# Agenda for assembly in cleanroom session

# String Assembly Differences

**DESY units (flushing issue)**

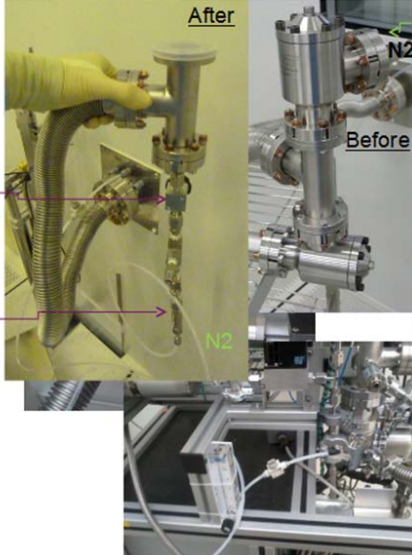
- Cavity and Nitrogen manual valves: identical => pump damaged or process delay... manual => if forgotten cavity back to HPR...
- Do: different type of manual valves for nitrogen line on each pumping unit  
Aptech springless series AZ30  
2 10-10mbar/s
- Check: leak tightness and particulates generation : OK  
Ceramic Filter Removal Rating > 99.999999 % at 0.003 µm
- Analyse: CCC564 out of XM5 (N<sub>2</sub> forgotten) !!

## String Assembly Differences (cont.)

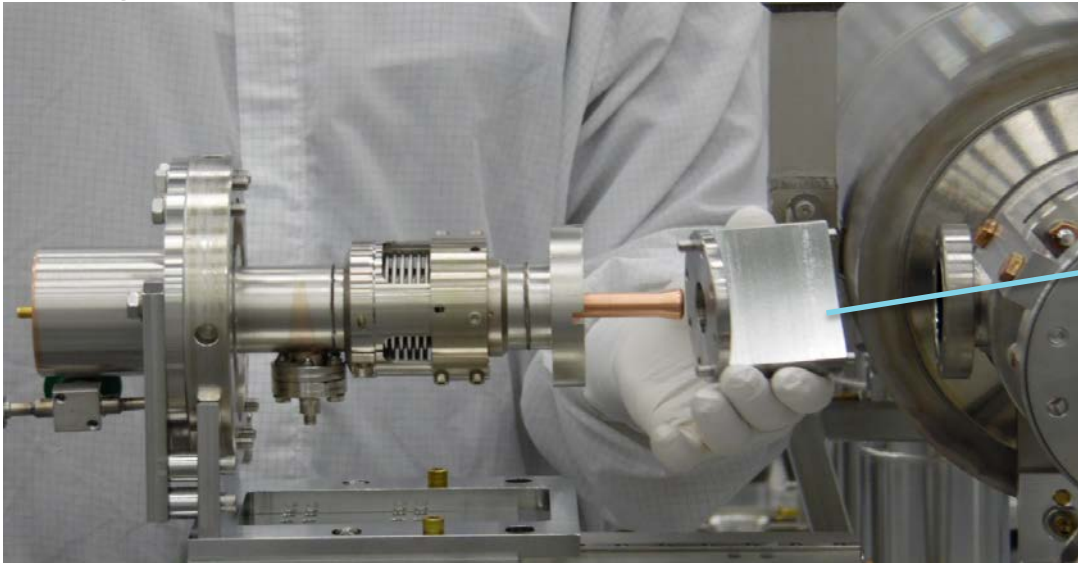
Recommendation noted to clean this tooling after each string assembly

Better process control and quality assurance checks to eliminate the alignment problems encountered during assembly of pCM

# String Assembly Differences (cont.)

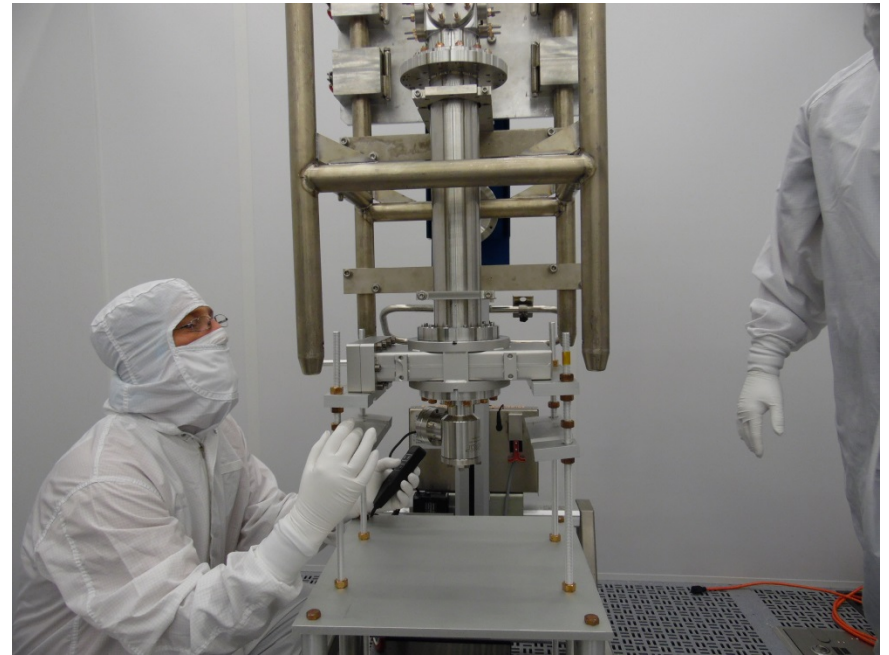
Modified for ProdCM string assembly, it will be done in horizontal configuration

# String Assembly Differences (cont.)

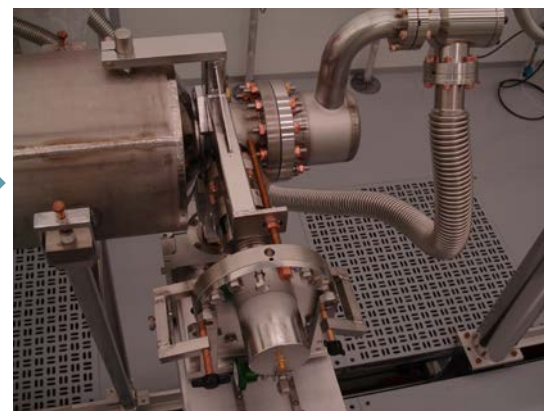
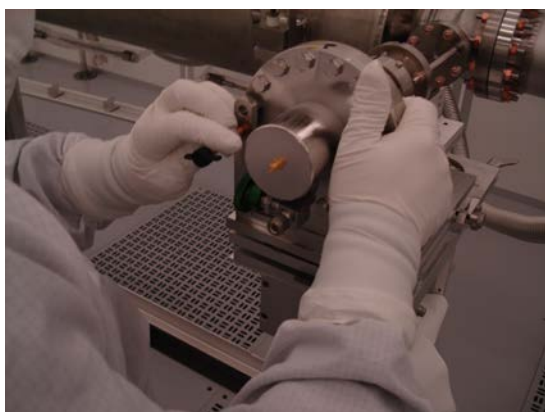
Recommendation noted for use of torque wrenches for LCLS-II strings assembly in the cleanroom

Over-torqueing of the fasteners to fix a leak is noted. DESY recommendation shall be reviewed further

# String Assembly-I (WS1)

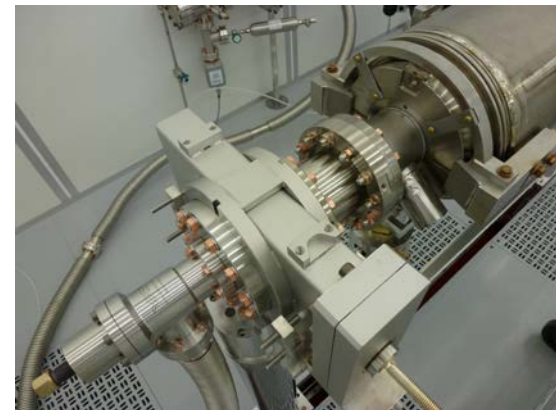
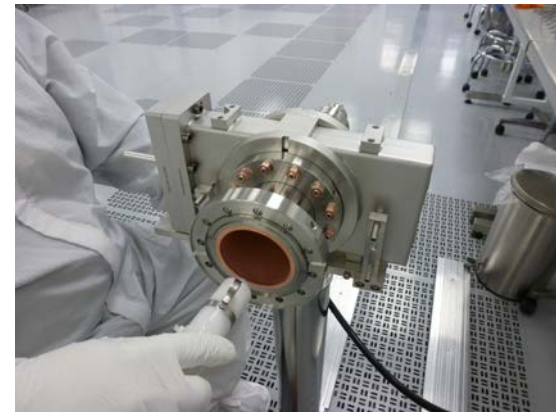
Recommendation noted that gate valve is opened and closed several times at JLab during particle free cleaning with ionized nitrogen

# String Assembly-III (WS1)

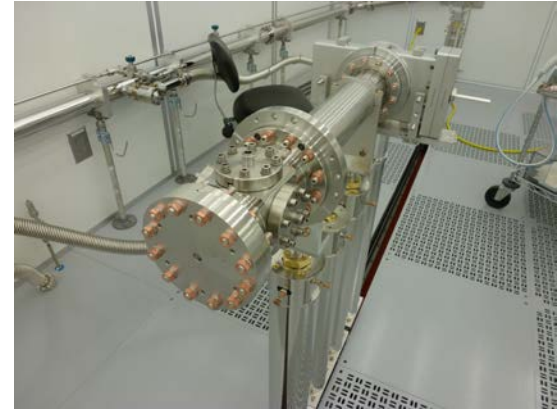
Alignment pins currently are not used at neither labs
